3.0 Site-Specific ITAAC

Figure 3.0-2 Breathing Air System Containment Isolation Configuration

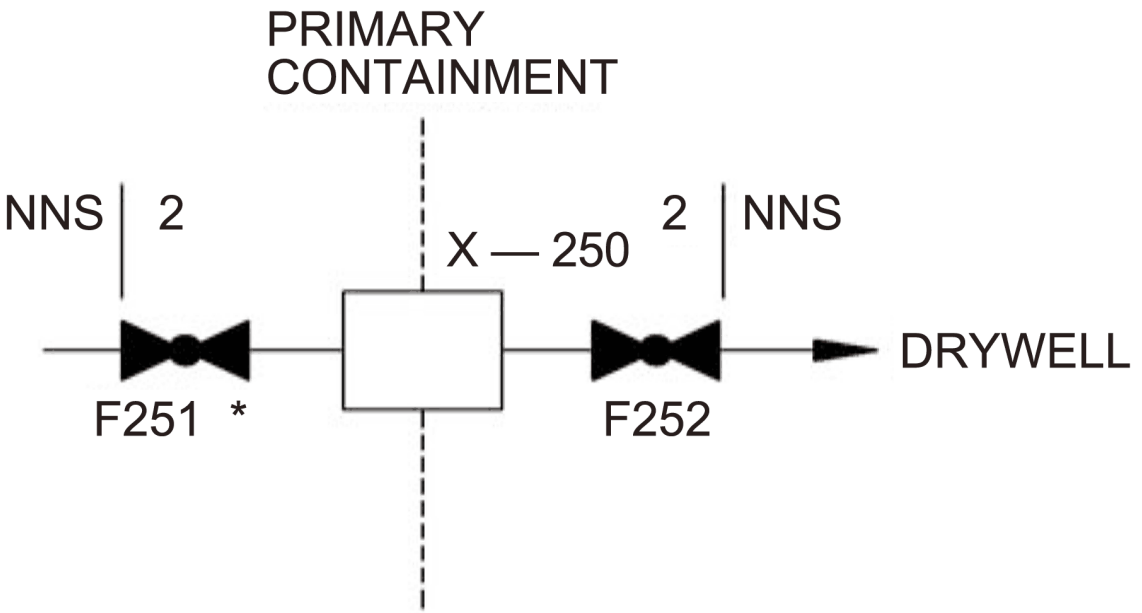
Design Requirement	Inspections, Tests, Analyses	Acceptance Criteria
1. The Basic BA System- containment penetration has one- locked closed isolation valve- inside and one locked closed- isolation valve outside- containment. basic configuration of the BAS is as shown on Figure 3.0-2.	1. Inspections of the as-built system will be conducted.	1. The as-built BA System- containment penetration has one- locked closed isolation valve- inside and one locked closed- isolation valve outside- containment. BAS conforms with the basic configuration shown on Figure 3.0-2.
